Product Update Notice

RCS Sure Actuators

Sure Power 115V Power On Brake – Part#71-24

September 23, 2019

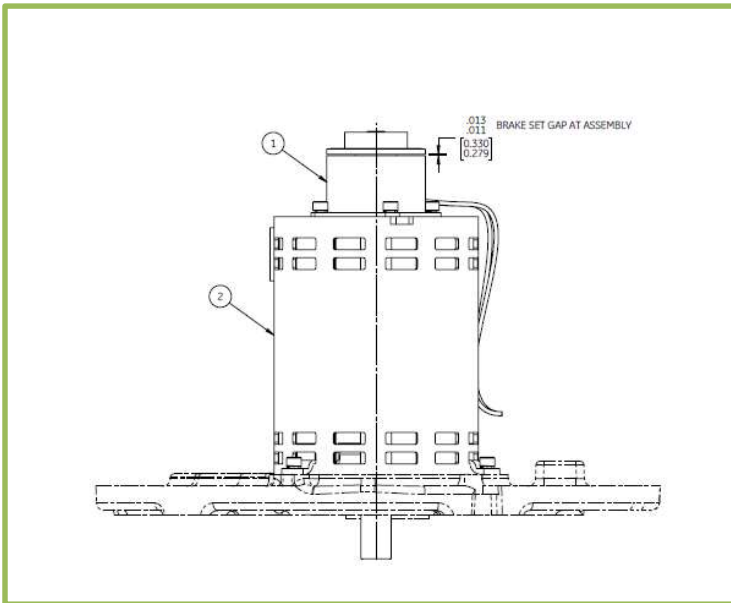
- Due to dual sourcing needs, ECN(Engineering Change Notice)#66095 approved Thomson Deltran brake (Vendor Part#BF-15J) to be used on our RCS Product line. This brake is interchangeable with our existent brake. Part#71-24 changed revision to D.
- Alternate brake from Thompson Deltran meets the all engineering specifications for our product. Brakes are 1 to 1 replacement. No form fit and function has been violated.
- Alternate brake from Thompson Deltran was tested and evaluated for our actuators.
- Brake was properly tested and added in all required certificate of conformance.

No changes in brake adjustment for Sure power actuator line with all approved brakes – **Part# 71-24**. Brake set gap assembly continues to be between 0.011" & 0.013". It is highly recommended to use a gage during installation to obtain an accurate gap during brake adjustment. A 0.012" gage is highly recommended.
